No.	Date	Revision/Issue
	12/08/08	DSA SUBMITTAL
	02/11/09	DSA SUBMITTAL
	5/11/09	DSA BACKCHECK
1A	12/16/2011	ADDENDUM 1A
1B	01/20/2012	ADDENDUM 1

MUIR FUNDAMENTAL SCHOOL MODERNIZATION

BUILDINGS 1 & 5 POWER PLANS

E3.1

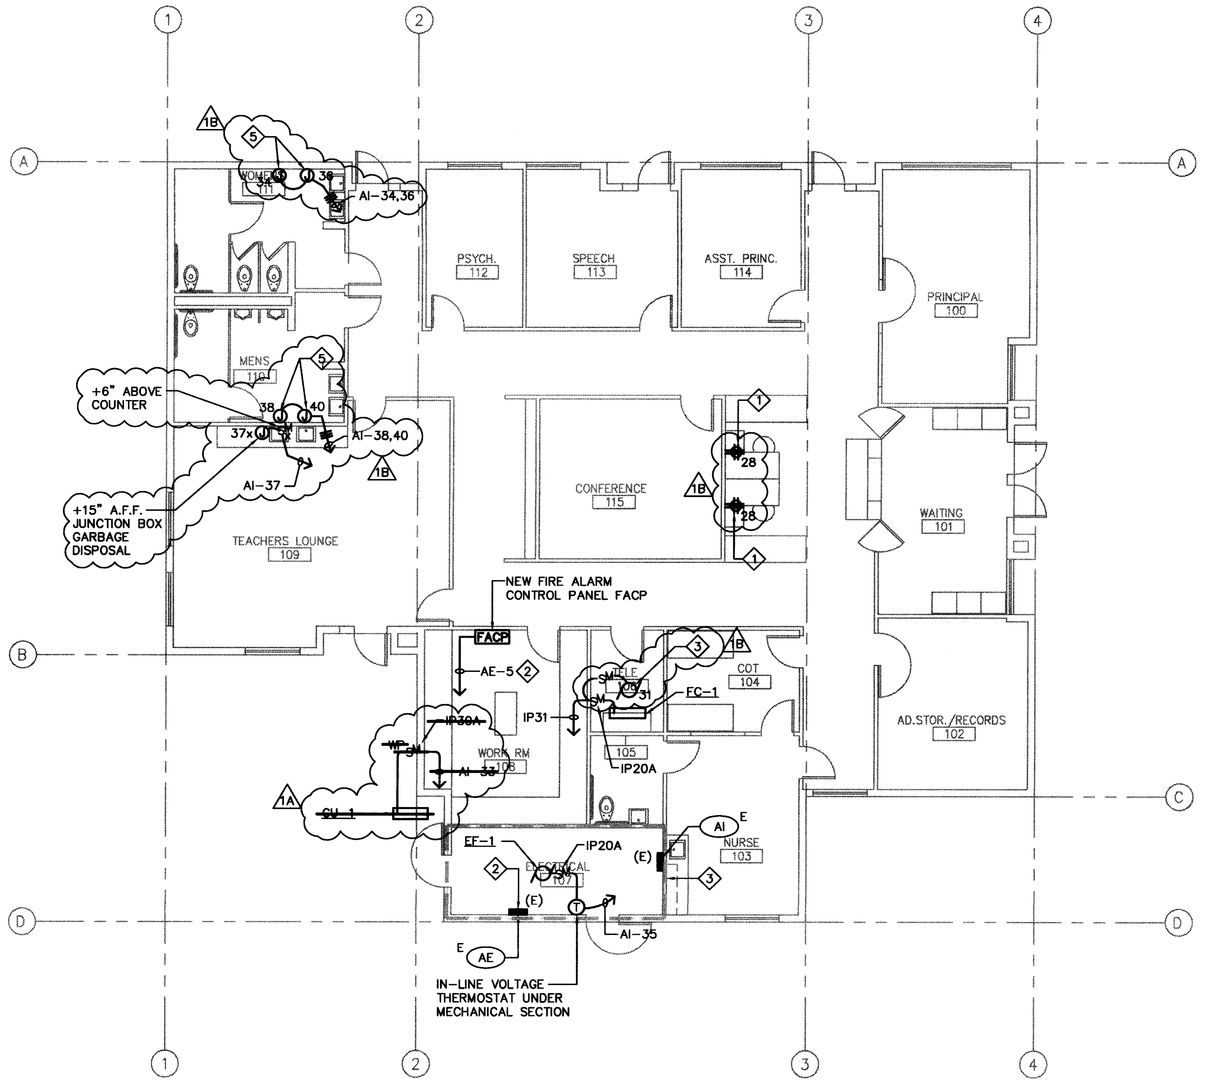
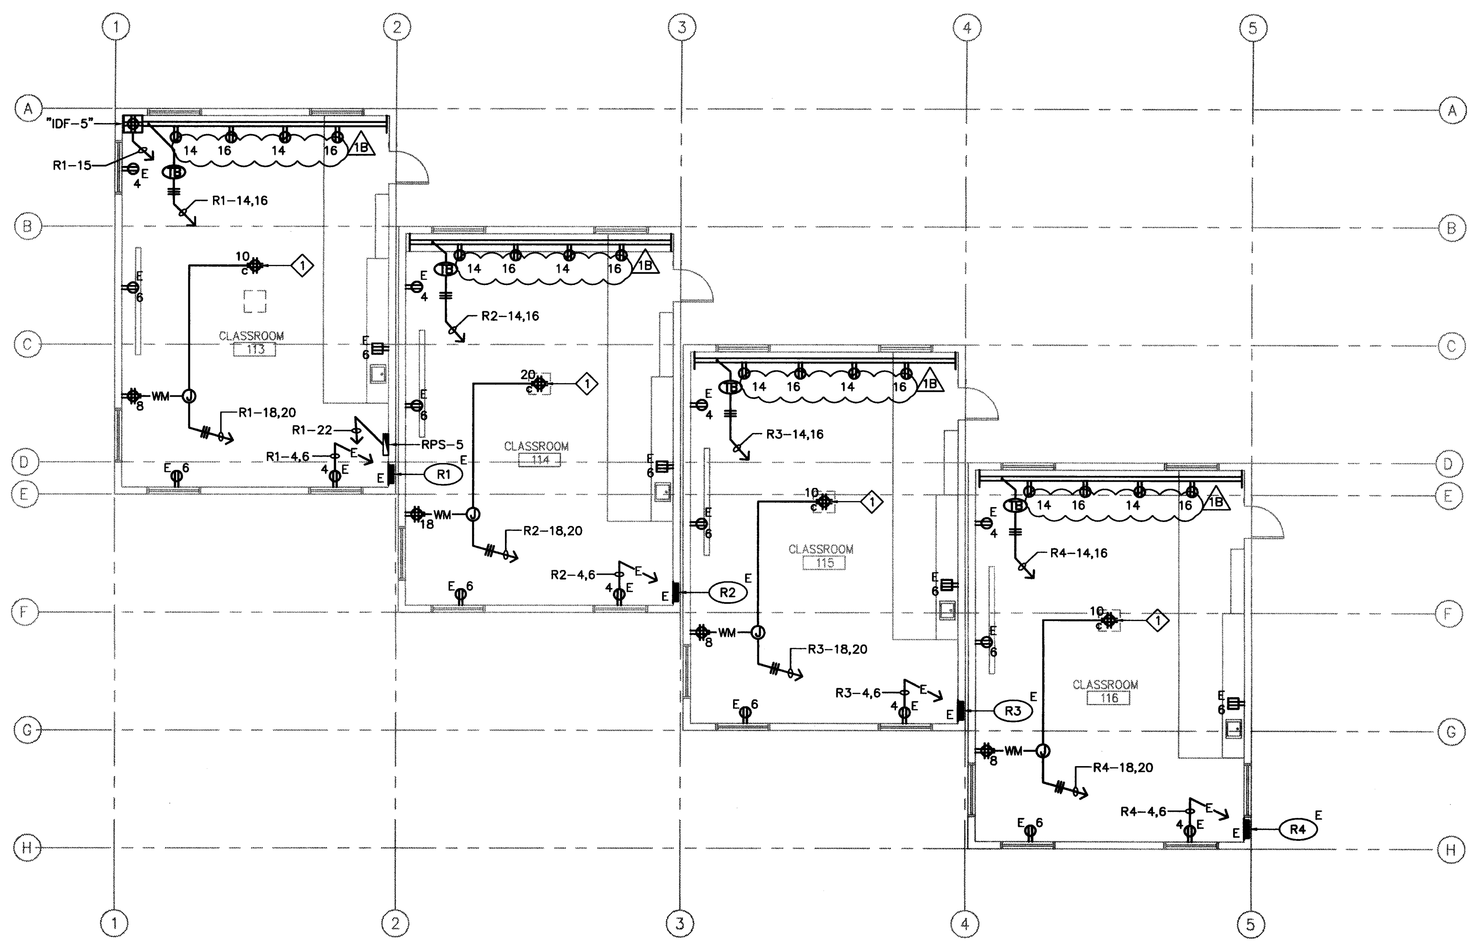
1B

KEY NOTES

1. PROVIDE/INSTALL DUPLEX RECEPTACLE MOUNTED ON CEILING FOR PROJECTOR.
